1st Further Information

**Proposed Temporary Warehouse (Excluding Dangerous Goods Godown) with Ancillary Facilities
for a Period of 3 Years and Associated Filling of Land and Pond in "Agriculture" Zone,
Various Lots in D.D. 107 and Adjoining Government Land, Fung Kat Heung, Yuen Long**

(S.16 Planning Application No. A/YL-KTN/1024)

Responses-to-Comments

DWG NO.
PLAN 1

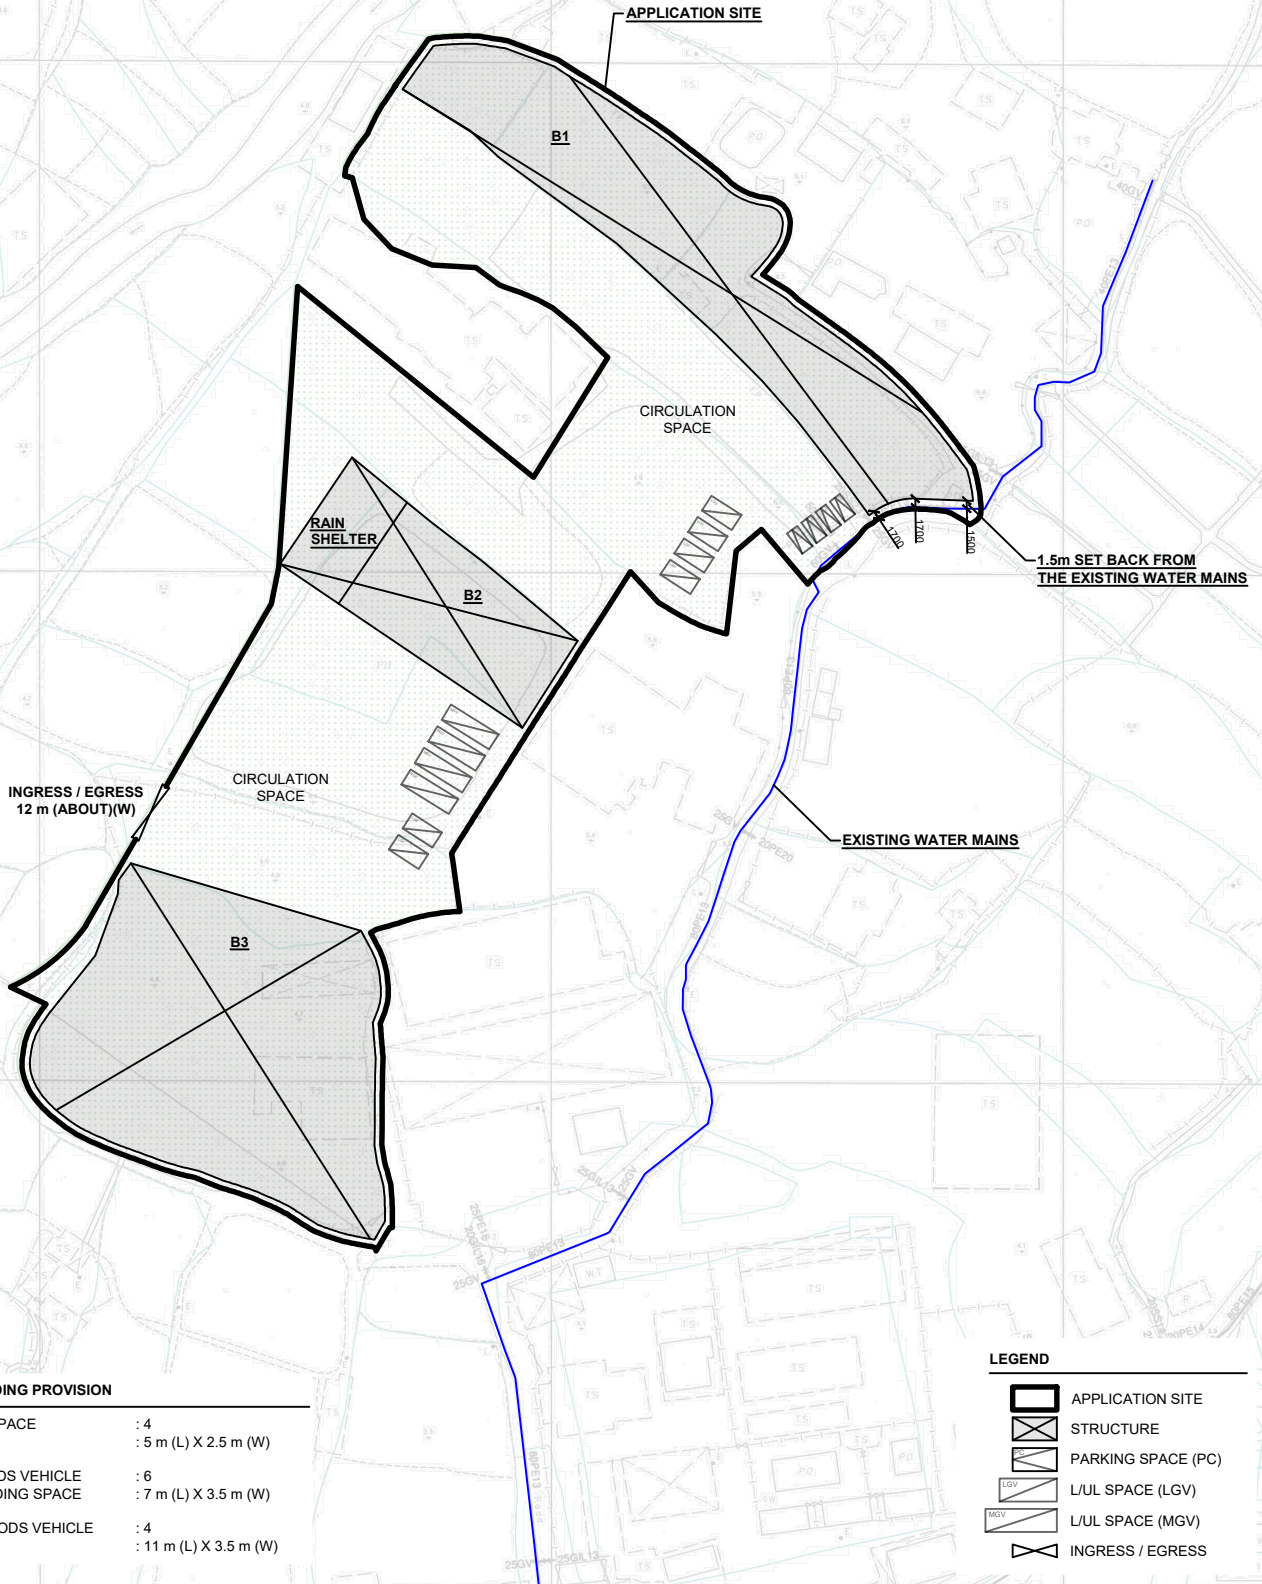
(c)	<p>As per the proposed layout and paving plan, the applicant shall justify the use of the open area and the necessity of the proposed filling of land and pond.</p>	<p>Since the applied use mainly involves ‘warehouse (excluding dangerous goods godown)’ operation, particularly related to logistic and storage activities, often involves large-scale production processes. These operations require adequate open space to accommodate machinery, equipment, parking and loading/unloading facilities, and production lines. Therefore, the Site with a large open area allows for the efficient layout and organization of these components. In addition, the proposed development requires specialized facilities in support of the daily operations (i.e. drainage facilities and fire service installations), having a larger space allows for the incorporation of these specialized facilities to support the</p>

7. Comments of Commissioner for Transport (C for T) (Contact Person: Mr. Phil CAI; Tel.: 2399 2421)		
(a)	The applicant should justify the need for two run-in/out within the site; and	The layout of the proposed development is revised for your consideration (Plan 1). Please be noted that only one 12m width ingress/egress is provided to facilitate the proposed development. A plan showing the swept path analysis is also provided (Plan 2).

- (i) Revised plans showing the layout, filling of land and swept path analysis of the application site (the Site) are provided (**Plans 1 to 3 and Annex I**).

- (ii) The layout of the proposed development is revised to meet the operational needs (**Plan 1 and Annex I**). 3 structures are proposed at the Site for warehouses (excluding dangerous goods godown), rain shelter, site office and washroom with total GFA of 7,321 m² (about). One 12m width ingress/egress is provided at the Site to facilitate the proposed development.

<p>operational needs.</p> <p>As heavy loading of structures and vehicles would compact the existing soiled ground and weaken the ground surface, concrete site formation is required to meet the operational needs and that has been kept to minimal for the operation of the proposed development. The applicant will reinstate the Site to a state that is suitable for farming after the planning approval period.</p>
<p>5. Comments of the District Lands Officer/Yuen Long, Lands Department (DLO/YL, LandsD) (Contact Person: Ms. S. L. CHENG; Tel.: 2443 1072)</p>
